DART AEROSPACE LTD	Work Order:	139993
Description: Fuel Filter Drain Line Assembly	Part Number:	E4736-041
Inspection Dwg: E4736 Rev: A		Page 1 of 1

E4736-041 FUEL FILTER DRAIN LINE ASSEMBLY

EAGLE COPTERS LTD CALGARY, ALBERTA, CANADA	
DRAWING NO. E4736	REV. A
TITLE DRAIN LINE	SHEET 1 OF 5
SCALE NTS

Subject: E4736 issues with the sleeve coupling

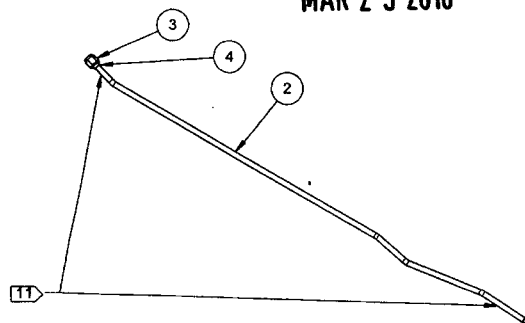
Change to Item 4 to MS20819-6D is acceptable to Engineering

The drawing E4736 (attached) calls out for sleeve couplings MS20819-6J/-10J on the different configurations within the drawing.

Assembly pointed out that the -6J and -10J are stainless steel couplings, and they figure that these should really be -6D and -10D sleeve couplings, which they have stock of.

I see in the Spec for MS20189 that the Code D is inactive for new design or replacement parts, and they claim to use no code or Code J or K. Seems a bit off that even though this is stated, we would put aluminum and steel together for galvanic corrosion reasons. Do you know have any opinions on what they should use?

Yes, those sleeves should be the "D" version or whatever the call out is for them to be aluminum.
